Origination Form
Proposed Revisions to a Standard Plans Index

Originator:	Gibbs, Shae	Index Number:	646-001
Date:	9/4/2025	Sheet Number(s):	1
E-mail:	shae.gibbs@dot.state.fl.us	Index Title:	Aluminum Post and Pedestal Mounted Pedestrian Detectors and Signals

ALUMINUM POST AND PEDESTAL MOUNTED
PEDESTRIAN DETECTORS AND SIGNALS

INDEX
646-001

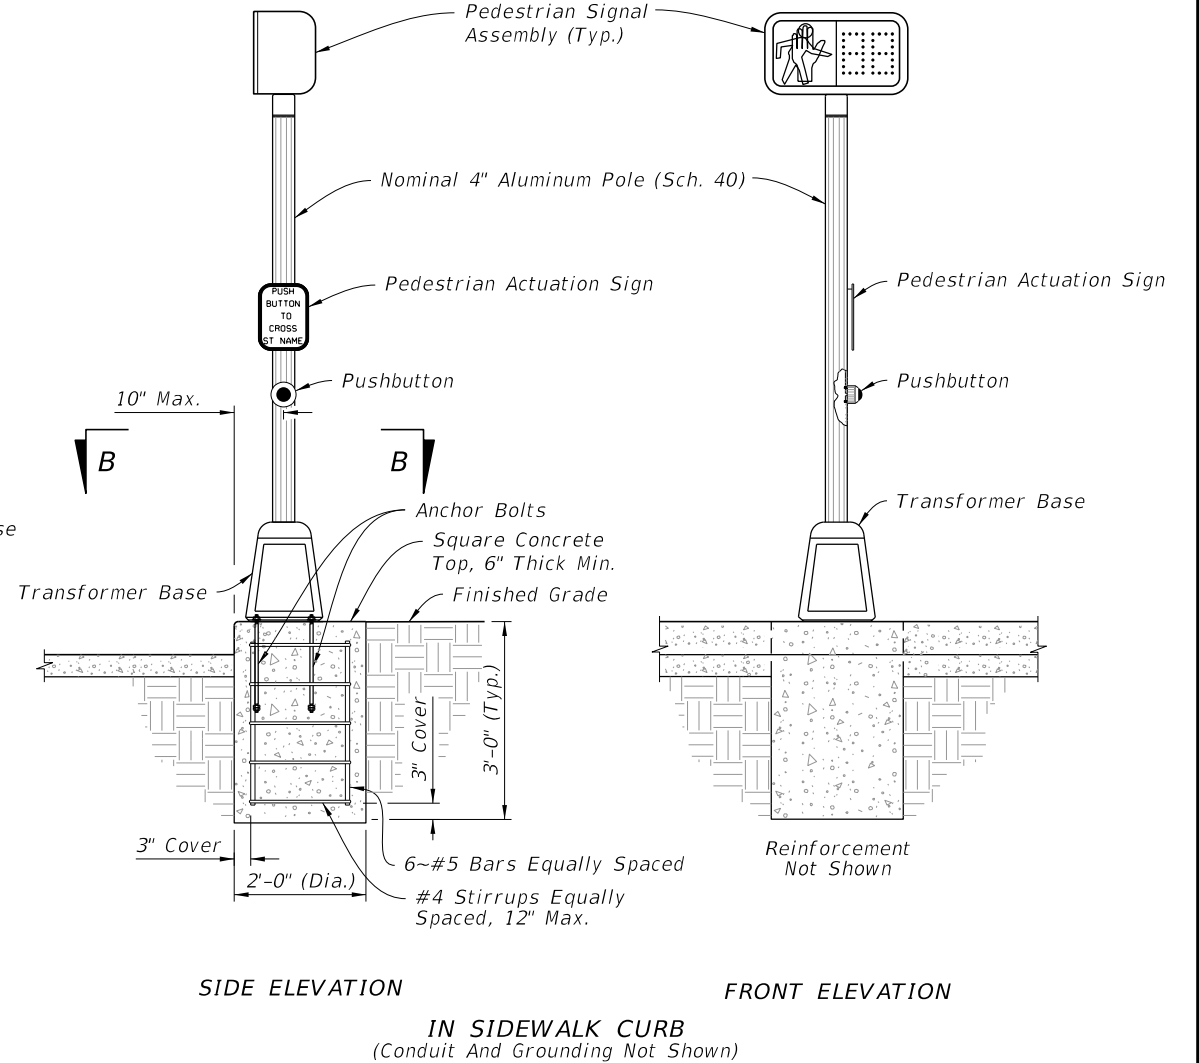
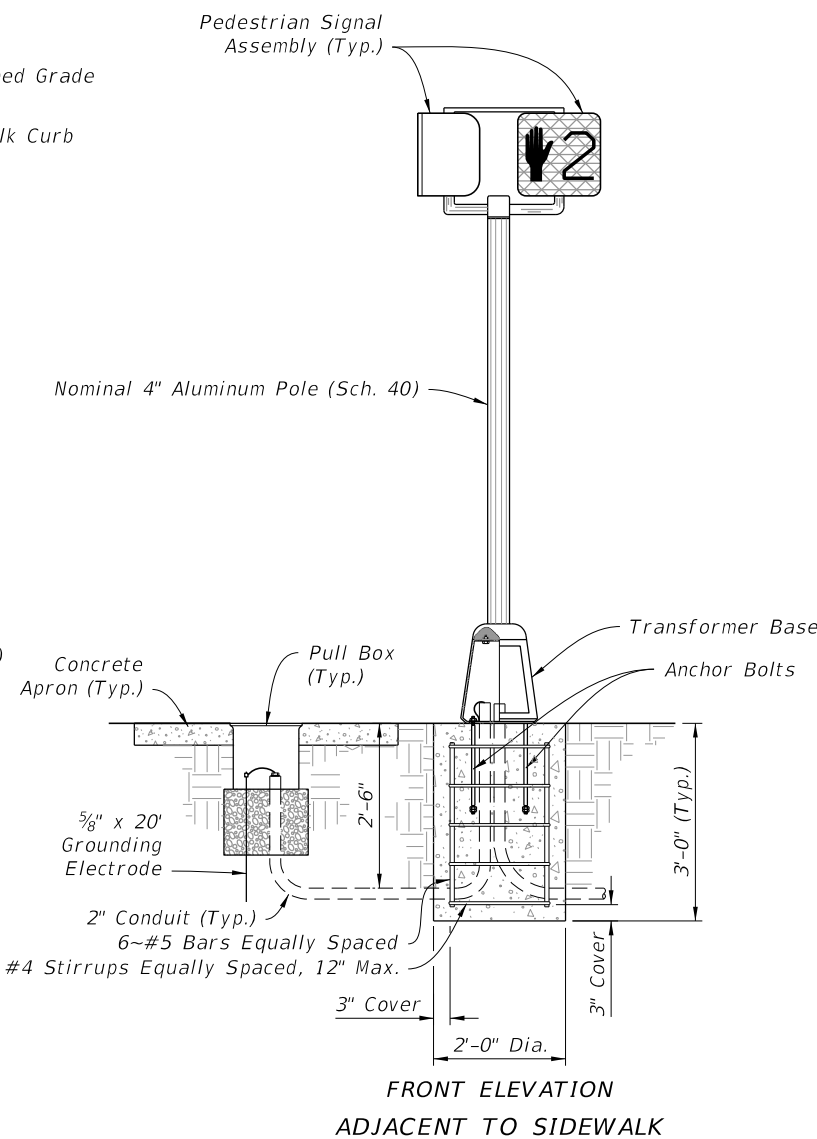
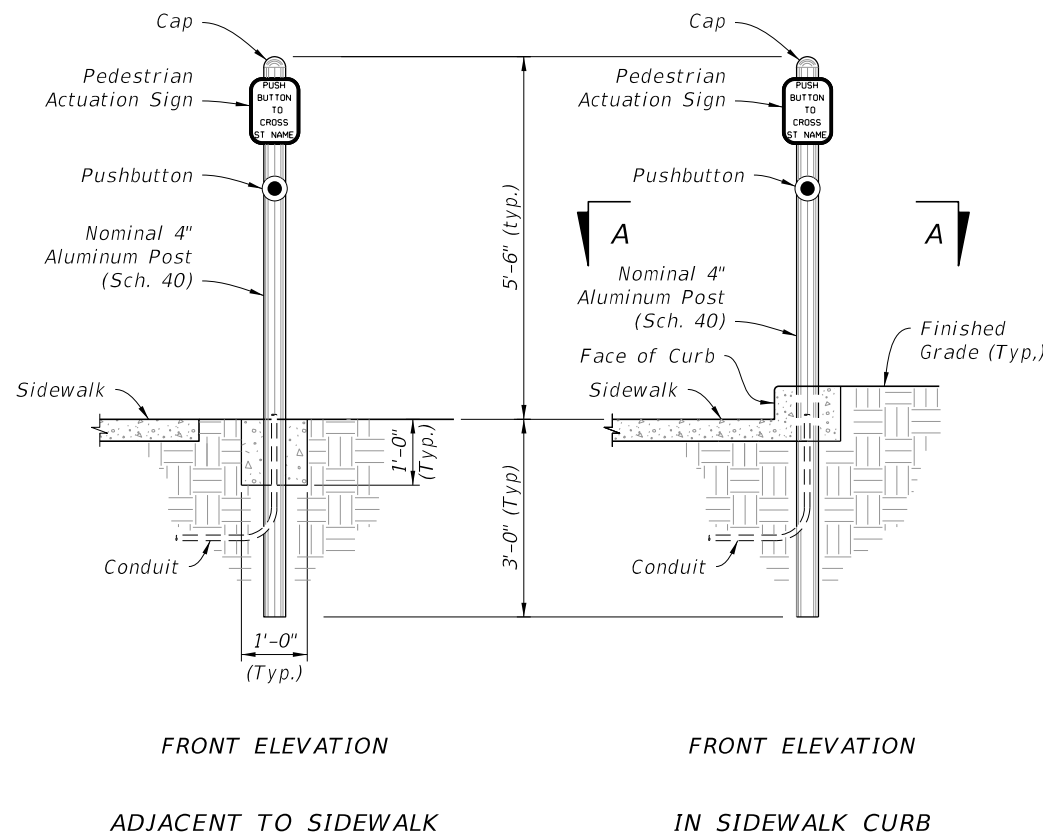
Sheet 1: Added Note 7 "For pedestal mounted signals, route and terminate the grounding electrode conductor to a ground lug within the transformer base."

7. For pedestal mounted signals, route and terminate the grounding electrode conductor to a ground lug within the transformer base.

This note was added to correspond with Standard Plans Index 653-001 in coordination with the TERL.
